Notice of Allowability

10/520,163

Examiner's Amendment

Examiner's Amendment to the Drawings

Fig. 1

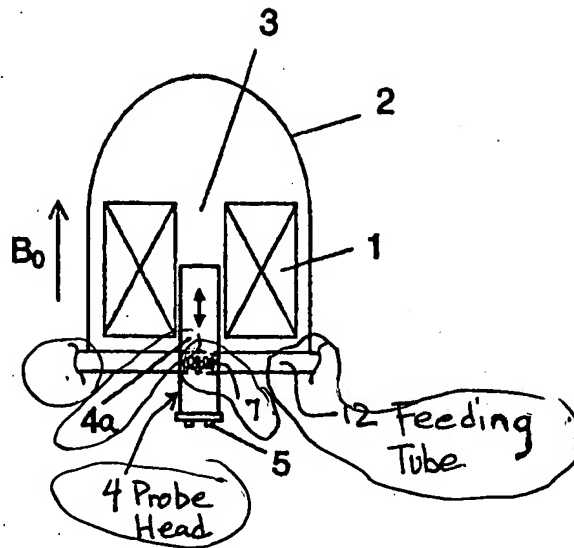
7. The following changes to the drawings have been approved by the examiner and agreed upon by applicant:
- A) Applicant will amend Fig. 1 adding a **reference number 4a** to indicate the body portion of the overall probe head **component 4**.

- B) Applicant will amend Fig. 1 to include an indication of the feeding tube 12.
 - C) Applicant will amend Fig. 1 to include **the appropriate indication on either end of component 12 that the feed tube component 12 extends outwards beyond the range of figure 1**, so that the correspondence between figs 2, 3, and 1 is clearly visible.

- D) Applicant will amend Fig. 1 to include **solenoid coil component 7**, which is also shown in the alternative orientations of figures 2 and 3.
 - E) Applicant will amend Fig. 1 to **show more clearly the broken lines** representing the area through which probe head 4 extends, via the lower opening, into the bore 3 of the magnet system 1.

Fig. 3

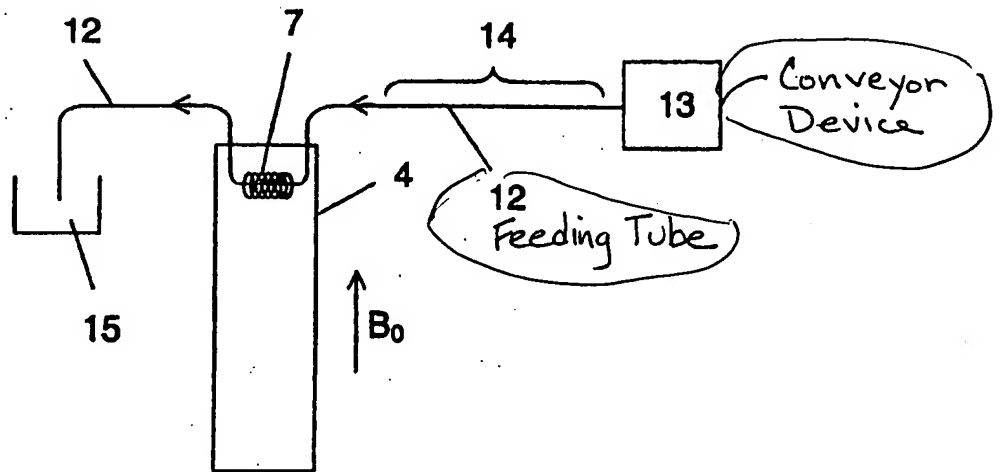
- H) Applicant will amend Fig. 3 to include the label of "**conveyor device**" for the blank box **component 13**.

- I) Applicant will amend Fig. 3 to include the label of "**feeding tube**" for the **component 12** so that it is clear that component 12 is a tube with the arrows identifying the directional aspect of the NMR probe system, as opposed to a simple schematic line.
8. In order to **avoid abandonment** of the application, **applicant must make these above agreed upon drawing changes.**

Fig. 2

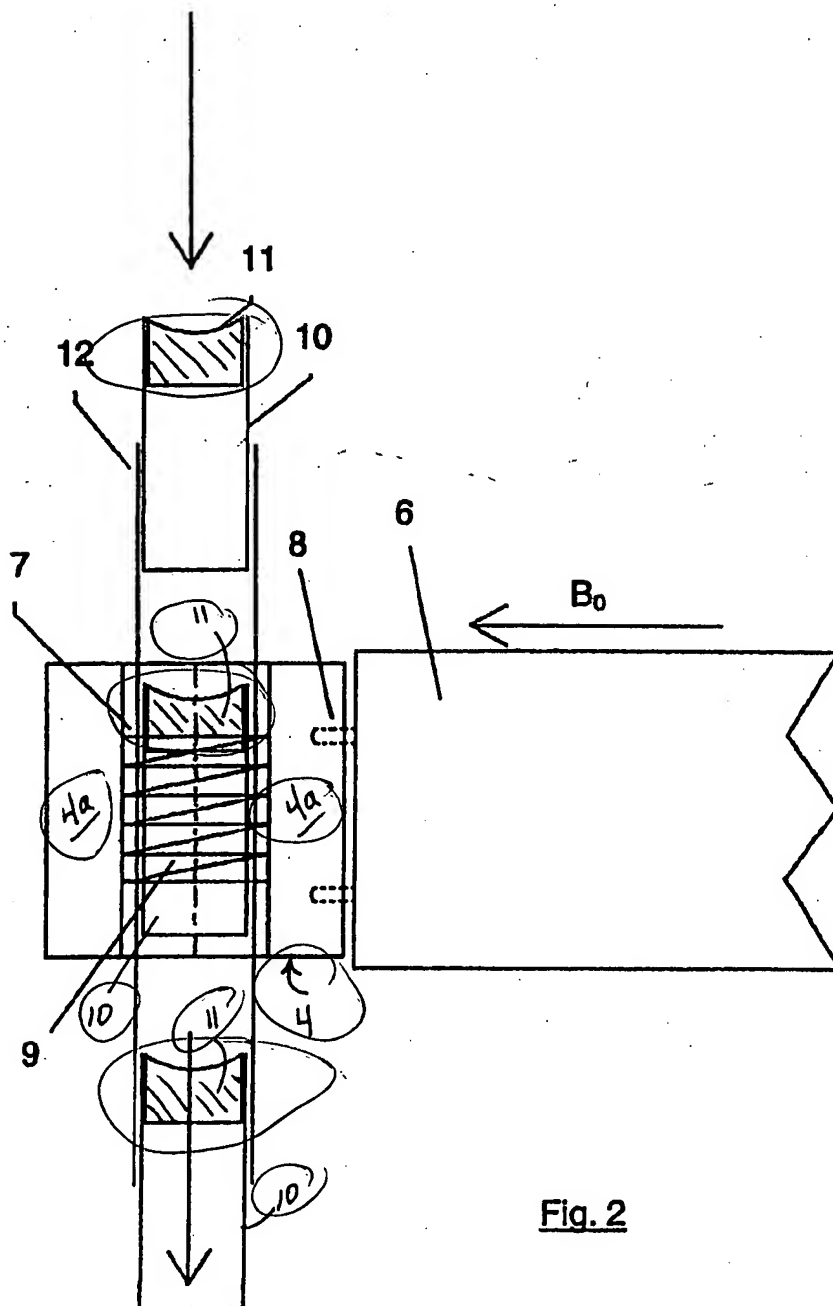
- F) Applicant will amend Fig. 2 to include component numbers **4a, 4, 10, and 11** where ever they occur in **figure 2**, as a means of clarifying the structure shown.

- G) Applicant will amend Fig. 2 to include hatched lines in combination with **plug component 11** so that the plugs and **sample containers 10** become more clearly visible in relationship to applicant's **NMR probe head 4**.
